Access Compliance Report

Public Rights-of-Way

Intersection ID: 10037649	Main Street: SEVENTY SEVEN CENTER DR	Cross Street: N/A	Location: SW
ADA ID: 73D5C21FDD26	Ramp Type: Perp	Initial Pass/Fail: Fail	Overall Compliance: No
Severity Score: 22.5			
Codes/Mitigation Info/Possible Solution		Field Measurements/Component Compliance

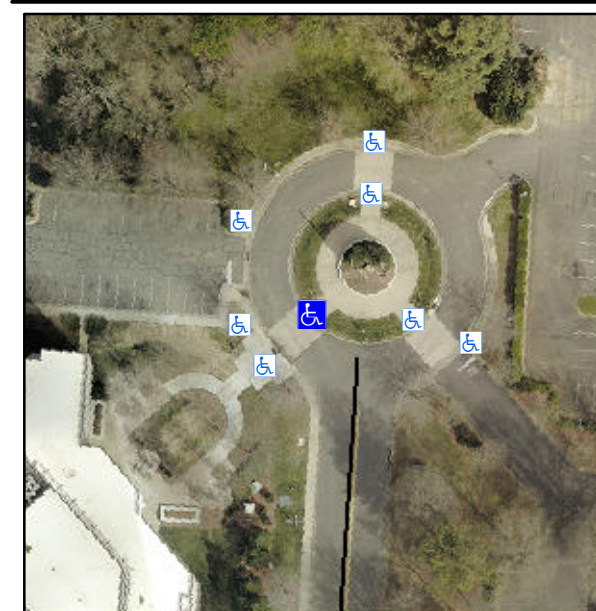
R304.5.1, R304.2.2, R304.5.3

Compliance	Description	Data	Compliance	Description	Data
N/A	Ramp Length (in)	58.0	No	Ramp Slope (%)	8.8
No	Ramp Width (in)	38.0	No	Ramp XSlope (%)	2.5
N/A	Flare Type LT	N/A	N/A	Flare Type RT	N/A
N/A	Flare Slope LT (%)	N/A	N/A	Flare Slope RT (%)	N/A
N/A	Flare Traversable LT?	N/A	N/A	Flare Traversable RT?	N/A
N/A	Landing Length (in)	N/A	N/A	DWS Provided?	N/A
N/A	Landing Width (in)	N/A	N/A	DWS Contrast?	N/A
N/A	Landing Slope (%)	N/A	N/A	DWS Length (in)	N/A
N/A	Landing X Slope (%)	N/A	N/A	DWS Full Width?	N/A
N/A	Landing Curb? (Y/N)	N/A	N/A	DWS Offset (in)	N/A
N/A	Shared Landing?	N/A			
N/A	Gutter Ponding?	N/A	N/A	Gutter Slope (%)	N/A
N/A	Gutter Lip Ht (in)	N/A	N/A	Gutter X Slope (%)	N/A
N/A	Painted X Walk1?	No	N/A	Painted X Walk2?	N/A
	X Walk 1 Direction	To SW		X Walk 2 Direction	N/A
N/A	X Walk 1 Width (in)	N/A	N/A	X Walk 2 Width (in)	N/A
	X Walk 1 Slope (%)	1.1		X Walk 2 Slope (%)	N/A
	X Walk 1 X Slope (%)	1.1		X Walk 2 X Slope (%)	N/A

Remove & Replace Entire Ramp.
